East Anglia ONE North and East Anglia TWO Offshore Windfarms

Applicants' Comments on SASES' Deadline 9 Submissions

Applicant: East Anglia TWO and East Anglia ONE North Limited
Document Reference: ExA.AS-6.D10.V1
SPR Reference: EA1N_EA2-DWF-ENV-REP-IBR-001056

Date: 6th May 2021
Revision: Version 1
Author: Royal HaskoningDHV

APPENDIX 1
SuDS Basin Overlay Plans

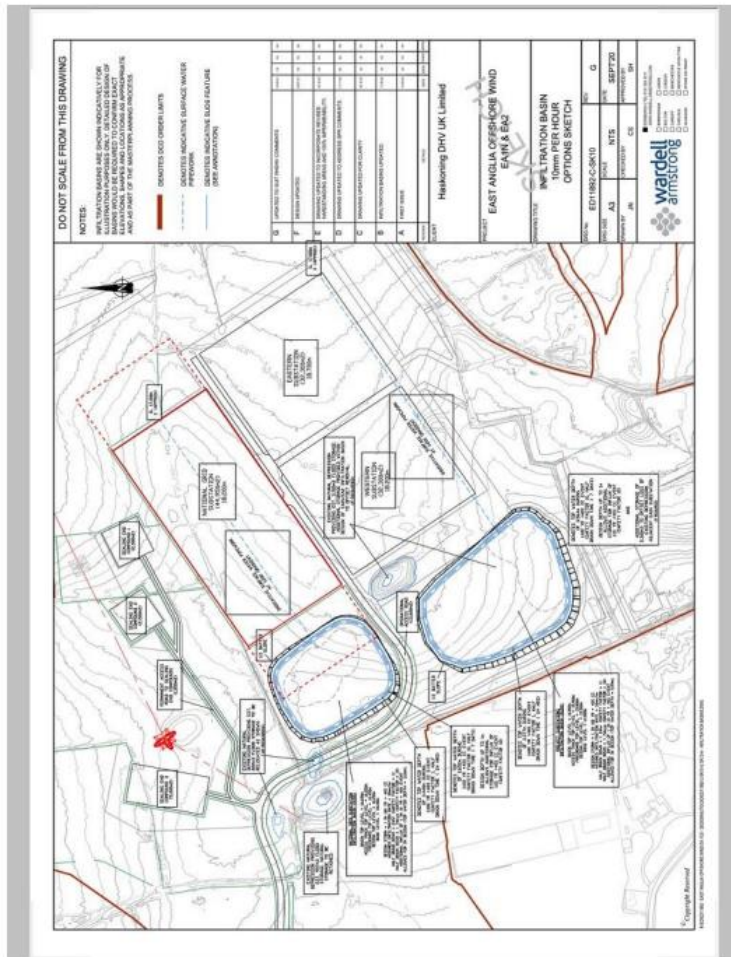
35	<p>The location of the western NG extension would overlap with the proposed area for one of the SUDS the drainage basin. This would be true for the drainage basin as currently shown on the OLMP and there would be an even greater overlap if the larger infiltration ponds were implemented. This would raise issues regarding where they could be relocated.</p>	Please see response at ID27.
36	<p>Vp 5 represents the area from which there will be one of the most significant adverse impacts due to:</p> <ul style="list-style-type: none"> • Proximity to the substations • The extent of development across the landscape visible a single viewpoint; and 	<p>The Applicants agree that Viewpoint 5 represents the area from which there will be significant visual effects as a result of the combined effect of the onshore substations, National Grid substation and potential extensions, as assessed in ES Chapter 29 (APP-077) and Landscape and Visual Impact Assessment Addendum (REP4-031).</p>

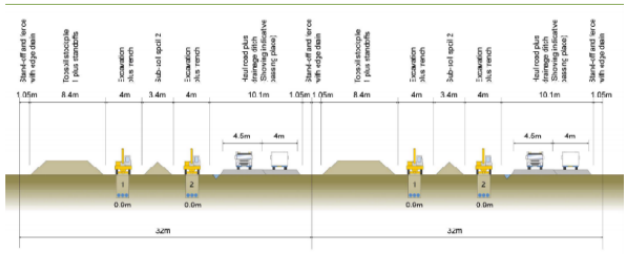
16	<p>The Applicants did not describe or illustrate at CAH3 their Indicative Cable trenching arrangement and working area to include two separate haul roads in the event that 'Scenario 1' prevails i.e. EA1N and EA2 constructed concurrently. This default arrangement was illustrated by SPR on Display Boards at its final and formal Phase 4 / Section 42 public consultation : Slide 2 of Appendix 9.10 of 5.1.9 Phase 4 Public Exhibition Boards [APP-038] as illustrated below and attached.</p>	<p>SASES' statement that the 'default arrangement' was illustrated on Display Boards is misleading. The Display Boards clearly state that the illustration is "indicative". The illustration shows the worst case scenario of both projects being constructed to the extent of the maximum parameters, which is wholly appropriate to illustrate. The Applicants have also stated in Written Summary of Oral Case Compulsory Acquisition Hearing 3 (REP8-100) that:</p> <p><i>"if the Projects are built concurrently, or sequentially (but with the ducting for the second project installed concurrently as the Applicants have committed to do (Project Update Note (REP2-007))), in order to ensure the Applicants can optimise the onshore cable route for both Projects, common Order limits for the onshore cable corridor have been established. This ensures that during detailed design, consideration can be given to the sharing of temporary works where feasible (such as haul roads, Construction Consolidation Sites (CCS) or drainage infrastructure) whilst retaining the flexibility to microsite each project's</i></p>

ID	SASES' Comment	Applicants' Comments
	 <p data-bbox="353 603 819 622">East Anglia TWO and East Anglia ONE North Indicative cable trenching arrangement and working area</p> <p data-bbox="353 734 743 762">www.scottishpowerrenewables.com</p>	<p data-bbox="1099 322 1937 386"><i>infrastructure to reflect ground conditions, ecological or archaeological constraints.”</i></p>

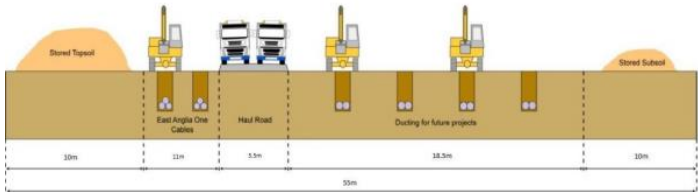
3	SASES considers that coordination of the SPR EA1N and EA2 projects would make a very suitable candidate for such a Pathfinder by allowing a much reduced number of cables and trenches to an existing National Grid substation site, at which the applicant already owns suitable land, thereby substantially reducing onshore environmental impacts. And this Pathfinder is understood to be compliant with the existing Ofgem regulatory environment.	The Applicants are at the forefront of offshore grid design. SPR have recently tested the HVDC market in relation to technologies for the East Anglia Three project and also in respect of the development of the latest HVAC technology for these projects. The comments made in documents about the pathfinder have focused on projects that are likely to be HVDC in the first place due to distance from land.
Original Proposal		
4	At OFH3 a proposal was made ([REP1-227], p175) for the alternative delivery of the output of the EA1N and EA2 windfarms by a coordinated 1.7GW HVDC Bipole link from an offshore platform to Bramford NGET	See Applicants' Comments on SASES' Deadline 5 Submissions (REP7-054) and Applicants' Comments on SASES' Deadline 8 Submissions (REP9-013).

ID	SASES' Comment	Applicants' Comments
	substation, via a single cable trench from Bawdsey landfall to Bramford NGET substation.	
5	This proposal was reiterated by SASES at ISH4 [EV-055] as a possible "Pathfinder" project in support of the BEIS OTNR review, but was only described in outline. Some clarification was provided in [REP5-107] whilst this updated document provides significant additional information and clarification about the proposal.	See <i>Applicants' Comments on SASES' Deadline 5 Submissions</i> (REP7-054) and <i>Applicants' Comments on SASES' Deadline 8 Submissions</i> (REP9-013).
Bawdsey to Bramford Cable Route		
6	<p>At the time of approval of the Applicant's East Anglia One (EA1) project it was agreed that a cable route comprising six cable trenches with two ducts/HVDC conductors per trench (12 ducts in total) would be constructed between Bawdsey and Bramford. However, following the CfD auction for EA1 the cable route design was modified to that shown in Figure 1 below to allow the use of HVAC for EA1 using two trenches.</p> 	See <i>Applicants' Comments on SASES' Deadline 5 Submissions</i> (REP7-054) and <i>Applicants' Comments on SASES' Deadline 8 Submissions</i> (REP9-013).

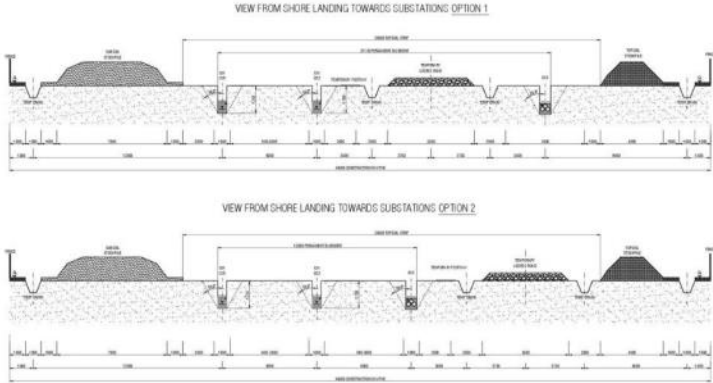
ID	SASES' Comment	Applicants' Comments
	<p>1.2GW to one or more customer bays at the adjacent NGET substation. This was shown as in Figure 2 below in the EA3 application documents.</p>  <p>Diagram 5.22 Typical Layout of a 1000MW HVDC Converter Station</p> <p>5.6.13 Onshore Substation (s) construction methods</p> <p>5.6.13.1 Site Establishment and Laydown Area</p> <p>463. During construction of the substation(s), site establishment and laydown areas would be required. The following would be required during the construction works:</p> <ul style="list-style-type: none"> • Temporary construction management offices; • Canteen; <p><small>Environmental Statement November 2015</small> <small>East Anglia THREE Offshore Windfarm</small> <small>Chapter 5 Description of the Development Page 123</small></p> <p>Figure 2 Original EA3 Converter Station Design</p>	
8	<p>However, the Applicant subsequently gained a relaxation of the DCO Regulation 29 order for EA1 to provide that only three cable trenches in total should be built, not the six originally committed to. The Discharge documentation for EA1 shown on page 24 of http://content.yudu.com/web/2it8t/0A4226m/CMS/html/index.html?page=24 illustrates the revised cable configuration for EA1 and EA3 as being that</p>	<p>See <i>Applicants' Comments on SASES' Deadline 5 Submissions</i> (REP7-054) and <i>Applicants' Comments on SASES' Deadline 8 Submissions</i> (REP9-013).</p>

ID	SASES' Comment	Applicants' Comments
	<p>shown in Figure 3 below, now with three ducts/cables in just one trench allocated to EA3.</p>  <p>Figure 3</p>	
9	<p>SASES initially presumed that the provision of three ducts in one trench was to allow the use of HVDC Bipole to connect the EA3 project to Bramford but recently published information (the Drawing from Ref. 1) records that the Applicant has chosen to use HVDC Symmetric Monopole, which will require only two of the three ducts.</p> <p>For clarification Ref. 1 states on page 4 that “The infrastructure to be installed for EA THREE, therefore, comprises:</p> <ul style="list-style-type: none"> • The landfall site with one associated transition bay location with two transition bays containing the connection between the offshore and onshore cables; • Two onshore electrical cables (single core); 	<p>See Applicants' Comments on SASES' Deadline 5 Submissions (REP7-054) and Applicants' Comments on SASES' Deadline 8 Submissions (REP9-013).</p>

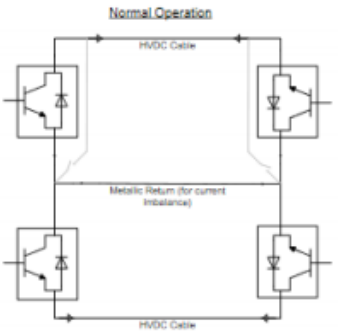
ID	SASES' Comment	Applicants' Comments
	<p>show (all much simplified) the onshore HVDC converters, all connected by just three conductors, which would be in one cable trench.</p>	<p>distance the more efficient and economic HVDC becomes. For East Anglia ONE North (69km) and East Anglia TWO (59km), HVAC cables are significantly more efficient for shorter distances.</p> <p>The Applicants refer SASES to Applicants' Comments on SASES Deadline 8 Submissions (REP9-013). Based on significant engagement with the supply chain, there are no HVDC technologies that will be cost effective for the Projects.</p> <p>Furthermore, the maximum capacity of a project than can bid for Contracts for Difference is 1500MW, so a 1700MW project would not be eligible in full. Two HVAC connected Projects at 900MW and 800MW retain the necessary flexibility in competing in the CFD process.</p>
